| <b>CASE#</b><br><b>2011-COA-308(IRV)</b>   | <b>INDIANAPOLIS HISTORIC PRESERVATION</b><br><b>COMMISSION</b><br><b>STAFF REPORT</b> | Hearing Date<br><b>SEPT. 7, 2011</b>                                       |
| <b>5703 UNIVERSITY AVENUE</b><br><b>IRVINGTON</b>  |   |  |
| <b>IHPC COA: 2011-COA-308 (IRV)</b> Enclose rear porch   |   |  |

Proposed plans – east façade

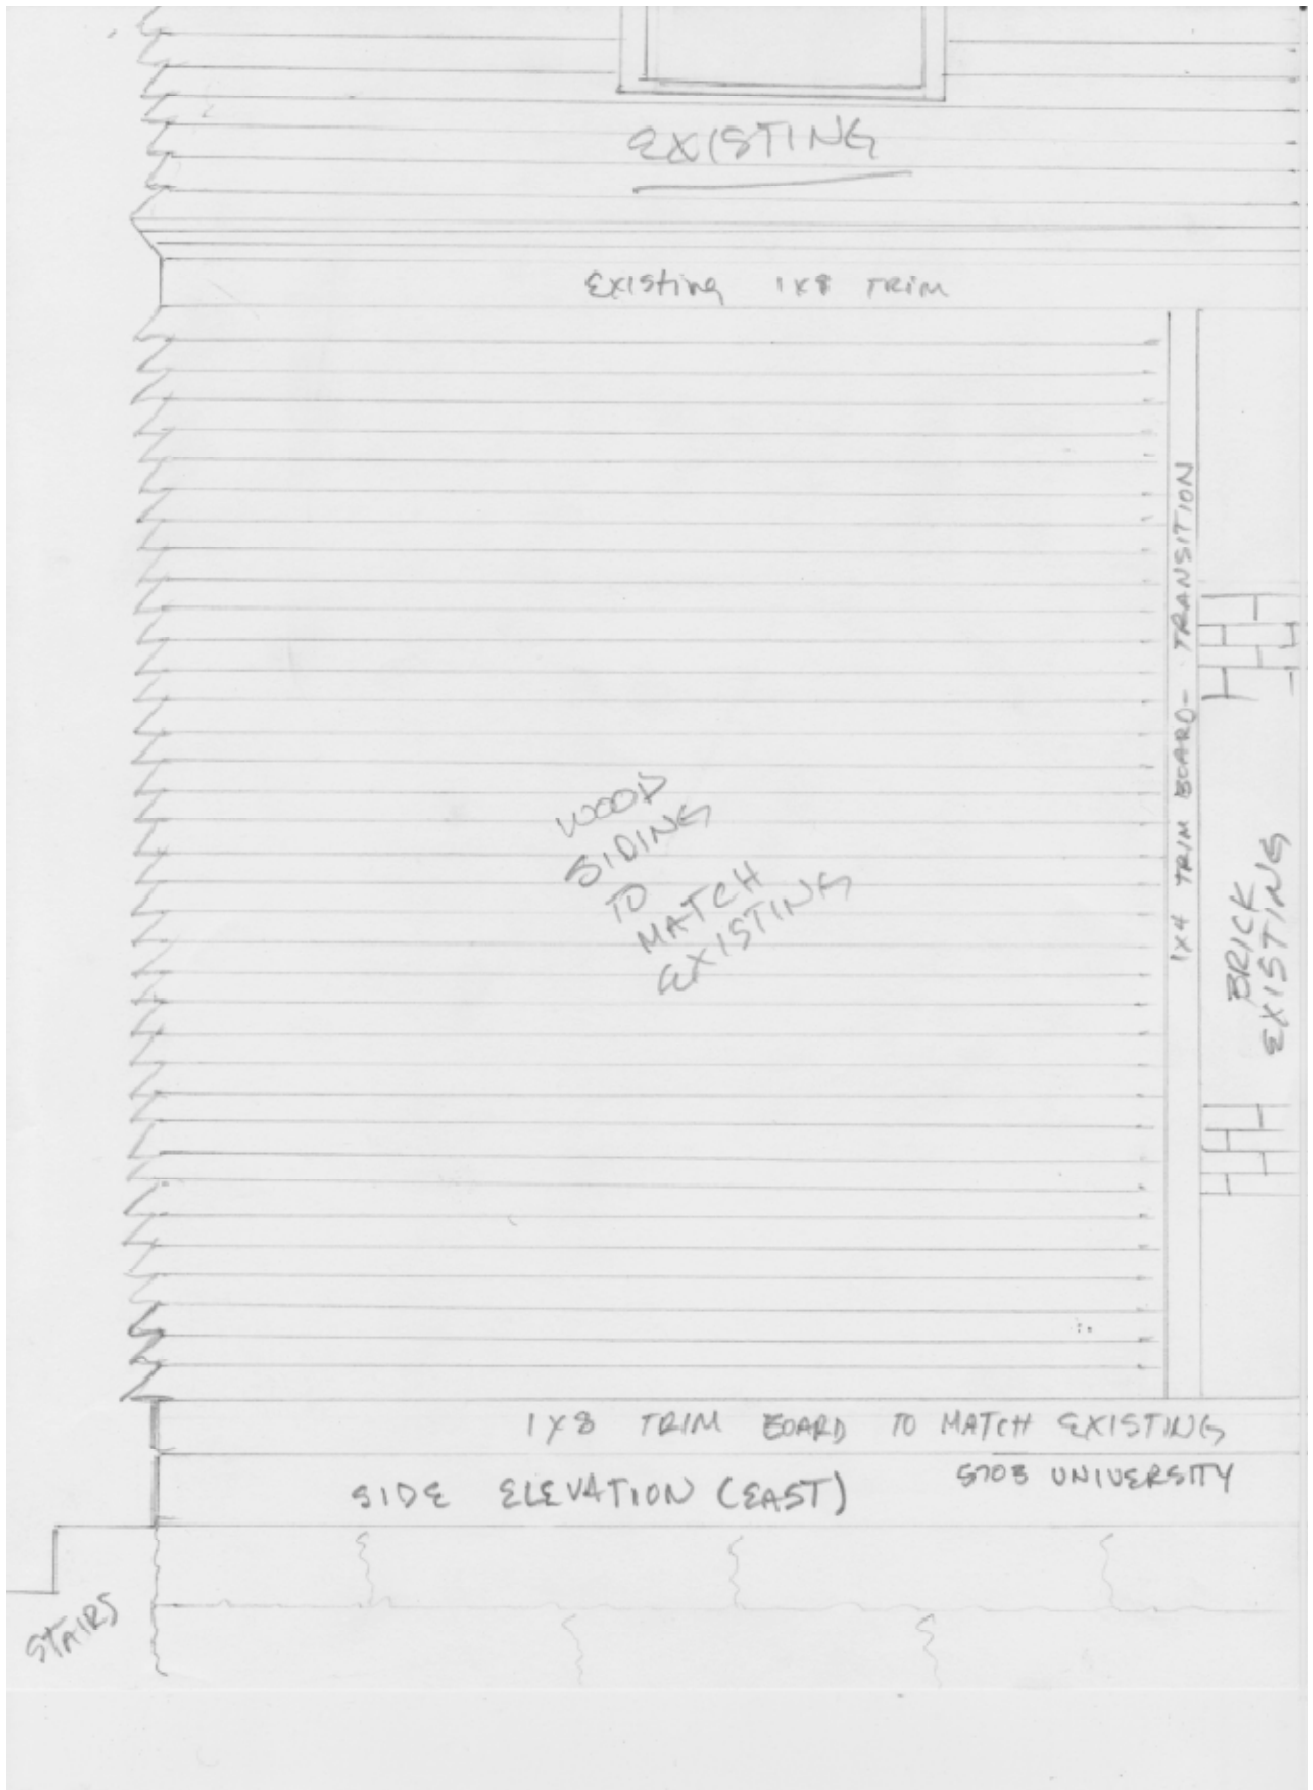
The applicants intend to enclose the porch using clapboard to match the reveal on the second story. They will utilize the existing historic half light door which will be relocated to the rear (south) façade. The door is 89 ¾ in. x 31 ¾ in. There will be a trim board to transition from brick to wood, and a new trim board will be installed right above the foundation. The enclosure will have very limited visibility from University Ave.

Drawings. Although the submitted drawings would not be sufficient for an actual addition to the house, in this case staff believes they are adequate to convey an understanding of the request. Since only two simple walls will be built, more detailed drawings are not necessary. There is a stipulation to approve final drawings and meet with the person building the walls before construction begins.

- 1) Final construction drawings shall be approved by staff prior to commencement of work.  
*Approved:* \_\_\_\_\_ *Date:* \_\_\_\_\_
- 2) A pre-construction meeting with IHPC staff, the owner, and the contractor must be held prior to commencement of construction. *Approved:* \_\_\_\_\_ *Date:* \_\_\_\_\_
- 3) Siding shall be wood clapboard, and shall match the reveal on the second story lap siding.
- 4) Siding and trim materials shall be wood and shall have a smooth texture free of major imperfections. **Rough-sawn finishes are not permitted.**
- 5) All exposed wood shall be pre-finished or painted.
- 6) The existing porch door shall be relocated and reused on the south wall of the enclosure.
- 7) Any changes to the approved scope or design shall be approved by IHPC staff prior to starting work.
